LaSalle County Station, Units 1 and 2
Facility Operating License Nos. NPF-11 and NPF-18
NRC Docket Nos. 50-373 and 50-374

Subject: Response to Request for Additional Information
License Amendment Request for Power Uprate Operation

Attachment
Response to Request for Additional Information

FIGURE 8a-1: Maximum Normal Heat Load: SFP Temperature Versus Days After Shutdown

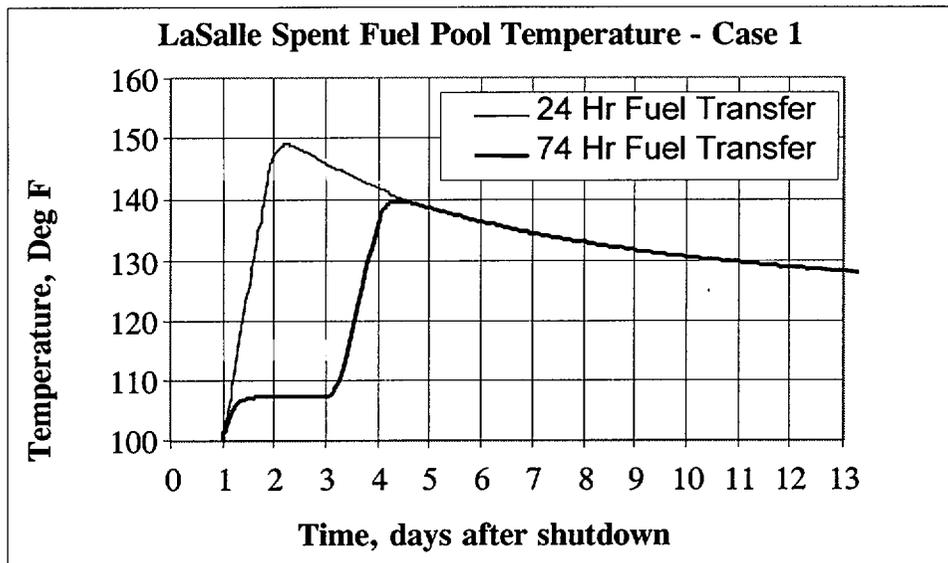
Provide the heat loads and corresponding peak calculated spent fuel pool (SFP) temperatures during planned refueling outages¹ and unplanned full core off-load.

In order to maintain the peak SFP temperature at or below the SRP criterion of 140°F, iterative calculations were performed for various "in-reactor" hold times. If the offload of fuel is delayed until 74 hours after reactor shutdown, the SFP temperature will peak at 140°F at 105 hours (about 4.5 days) after reactor shutdown, then decay. See Figure 8a-1

below. (Note that, because of the initial assumptions of 100°F SFP water in conjunction with 100°F Service Water, the SFP temperature rises slightly prior to the offload, due to the residual decay heat in the pool from the previous pool inventory of SFAs). The UFSAR will be revised, as a result of these power uprate analyses, to require refueling-specific analyses under the current plant conditions to be conducted prior to offload, to ensure that the 140°F criterion is not exceeded during an offload commencing within 24 to 74 hours after shutdown. Also, see the Response to NRC Question 10.

Figure 11-1: Decay Heat Curve Comparison Between ANS 5.1-1979 and ASB 9-2

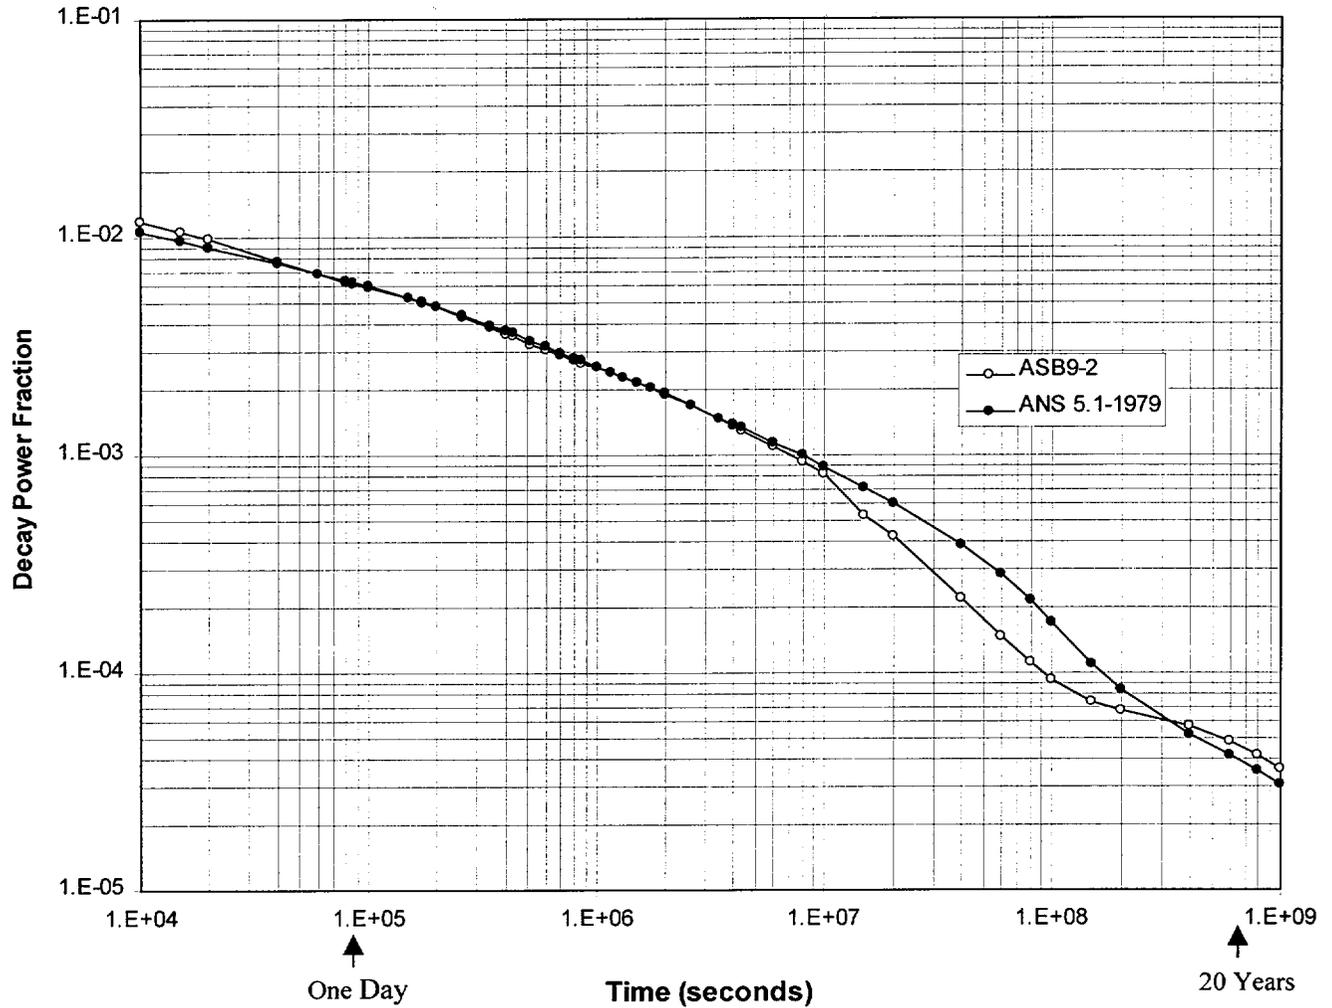
With regard to the SFP cooling, is the Branch Technical Position ASB 9-2, "Residual Decay Energy for Light Water Reactors for Long-Term Cooling" used to perform the decay heat calculations? If not, identify and provide the basis for any deviations and exceptions to the guidance described in Section 9.1.3 of the Standard Review Plan (SRP, NUREG-0800) including the Branch Technical Position ASB 9-2. Also, discuss the assumptions used to calculate the decay heat.

The GE power uprate evaluation is based on the ANSI/ANS-5.1-1979 decay heat standard, with the addition of two sigma uncertainty. This Standard was derived from a combination of experimental data and calculations. These power fractions are shown (Figure 11-1) to be representative of the curves presented in the NRC Branch Technical Position (BTP) ASB 9-2.

The NRC Standard Review Plan 9.1.3 recommends using the decay heat presented in the NRC Branch Technical Position, ASB 9-2. The decay heat curve used for these evaluations, ANS 5.1-1979 Standard with two sigma, is compared to the decay heat curve in ASB 9-2, in Figure 11-1. The decay curve shown in ASB 9-2 uses lower exposure than this GENE application, and therefore the ASB 9-2 decay curve was adjusted (increased) to match the exposure used in this application. Throughout the entire application range of 1 day to 20 years (8.64 E4 seconds to 6.3 E8 seconds), the ANS 5.1-1979 standard with two sigma has a higher decay heat ratio than the ASB 9-2 curve except for the following ranges:

Overall comparison of the two decay heat standards shows that the decay heat calculated by the ANS 5.1-1979 Standard is higher than that calculated by the ASB 9-2 curve for the SFP temperature calculations for LaSalle. This is true for both the heat loads resulting from the fuel discharged for Cases 1, 2, and 2a and for the heat loads from the previous cycles. Therefore, it is conservative to use the ANS 5.1-1979 Standard instead of the ASB 9-2 decay curve.
